1307 SAN PEDRO N.E.

STANDARD REQUIREMENTS FOR DRAINAGE PLANS

LOT 25 BLK 9

1 6 7 5
MICHAEL DEL MASTRO ARCHITECT
(successor to Louis G. Hesselde, architect, AIA)
1221 CENTRAL NE ALBUQUERQUE, NEW MEXICO 87106 (505) 243-4559

SITE PLAN

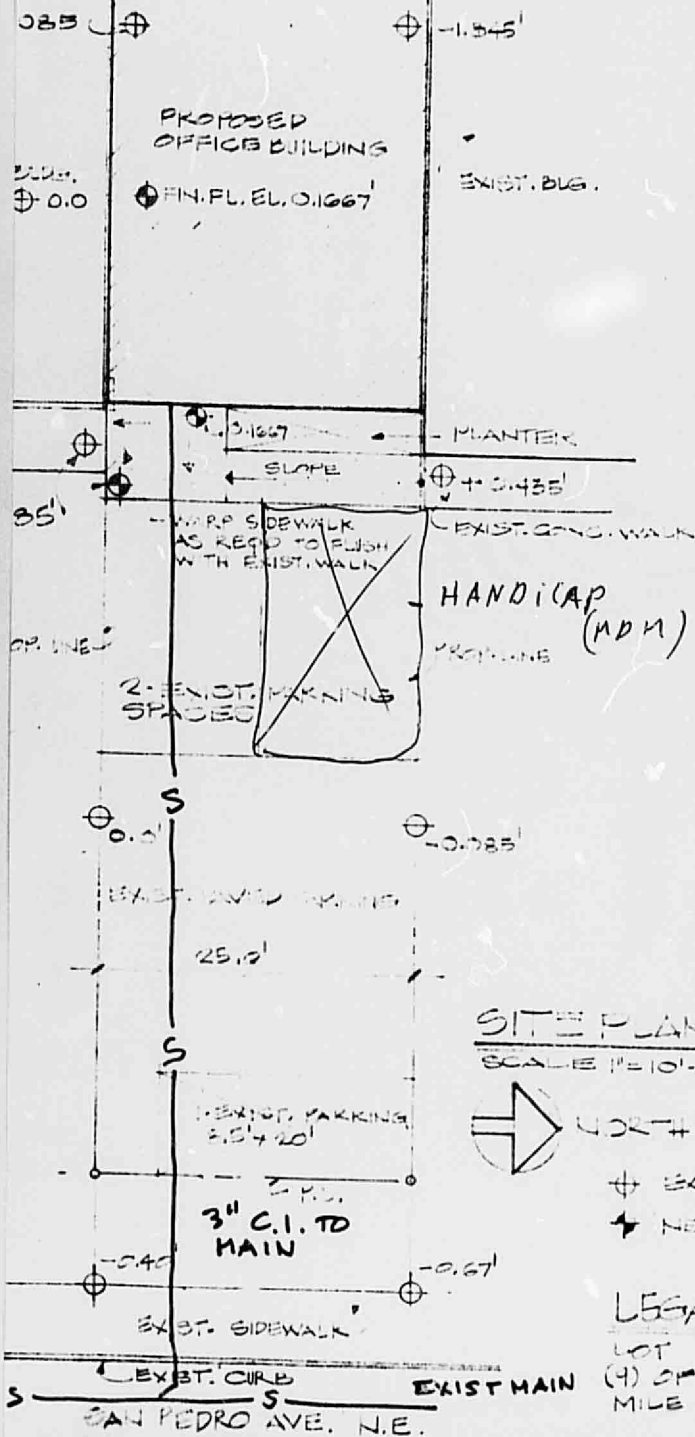
Attached is a copy each of the zoning map, and the site plan for a piece of property on which we are proposing to construct a 1500 s.f. office building. I discussed this matter with you and you indicated a waiver for the drainage regulation was feasible because this project is a small portion of an existing larger complex of buildings.

PAVE AND APPROPRIATELY
MARK THE LOCATION OF
THE SPACES PER CITY
STANDARD.
